Draft Development Control Plan 55 Pitt Street, Sydney Amended November 2020

## Sydney Development Control Plan 2012 – 55 Pitt Street, Sydney

November 2020

Figure 6.8A

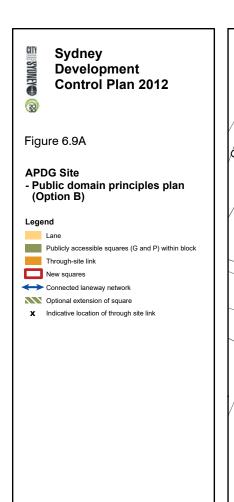
Replace Figure 6.8A as shown attached – *Amendments are shown clouded*

Figure 6.19
Development Control Envelope – 55 Pitt Street

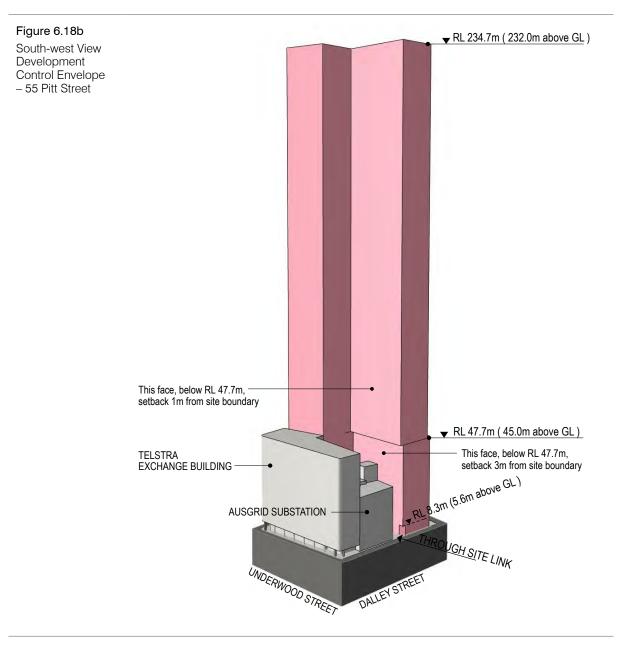
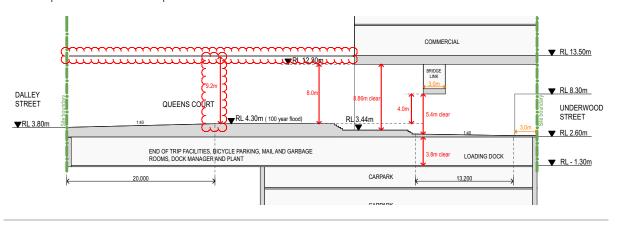
Insert new Figure – Through site link and bridge height – 55 Pitt Street – *Amendments shown clouded*

- (c) include a high-level glazed **roof/**awning to a minimum height of **9.2 10**m above the finished ground level, to ensure high quality amenity is delivered that supports outdoor dining;

- (d) incorporate public art to **conceal** the blast wall, bracing and **roof**/glazed awning in a holistic manner;
  - (e) have a minimum clearance of 5.4m between the underside of the bridge link over part of the through-site link and the finished ground level. The bridge link is to be no greater than 3m wide total external width.

- (f) reduce flooding impacts, be accessible and maintain clear sight lines from each end;
  - (g) include ground level as shown in Figure 6.19 to prevent a 100 year flood event passing through to Underwood Street;
